CITY OF OREGON CITY PLANNING COMMISSION AGENDA

Staff Report

GLUA-20-00020: CU-20-00002 / SP-20-00043 - 182 Warner Parrott Road -Proposed 30-Bed Residential / Memory Care Facility

EXECUTIVE SUMMARY:

• Figure 5: Original vs. Revised Site Plan (Dashed area indicates modifications) - Not to Scale

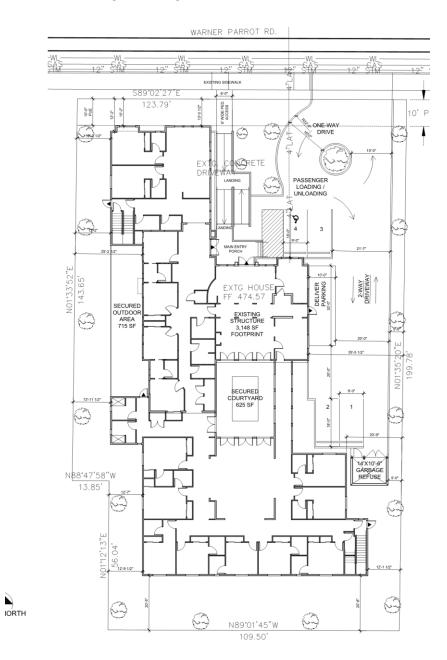
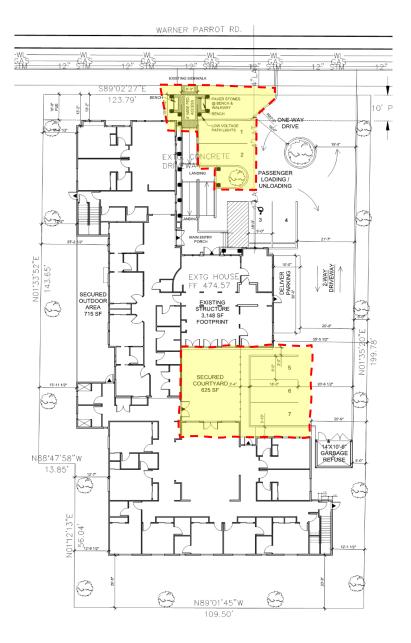
The applicant modified the proposal as follows:

- Reduce the size and overall mass of the building by opening the center courtyard.
- Addition of additional off-street parking to 8 spaces, including one delivery parking space. With 4 available on-street parking spaces abutting the property the total spaces is 12.
- Reduce lot coverage reduced slightly from 39% to 38%.
- Increased front window percentage.
- Revised landscaping due to increased off-street parking areas
